# Technical Bulletin

Subject: **Side Airbag Igniter, Diagnostic Trouble Code(s) (DTCs) Stored in DTC Memory**

Number: **05-02**

Model(s): **Touareg**

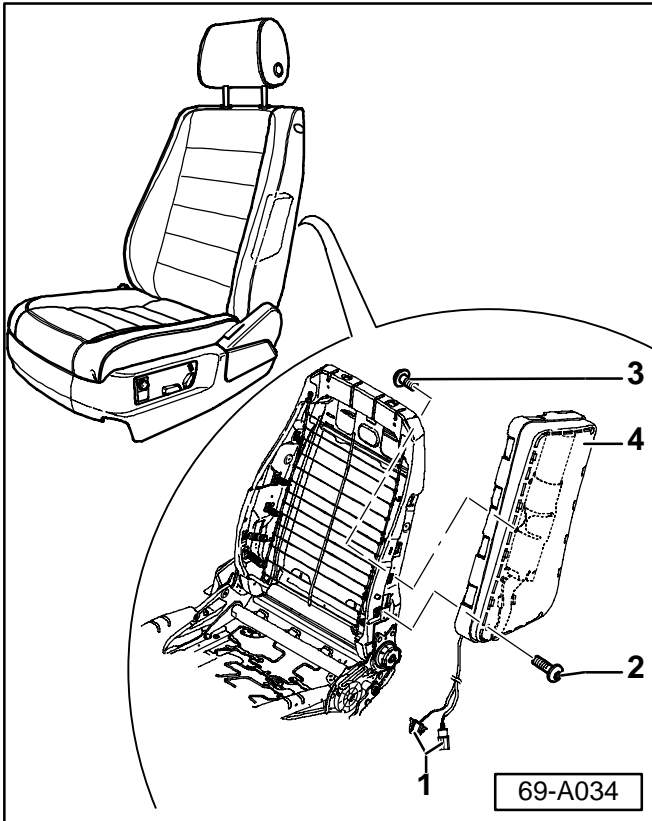
- Disconnect battery Ground (GND) strap.
- ◀ - Remove seat (see Repair Manual Group 72 Seat frames "12-way seat, removing and installing").
- Carefully separate connectors -1- of harness to side airbag igniter -N199- (driver seat) or -N200- (passenger seat).

- ◀ - Remove male and female side of the Yazaki connector (as shown) by cutting one wire at a time.
- Discard connectors.

- Splice the harness together using two 4in. sections of Repair wire Part No: 000 979 010 (from VAS 1978AR wiring repair kit) and 4 butt connectors Part No: 111 971 941A) from wiring harness repair kit 1978.
- ◆ This allows the harness additional slack.
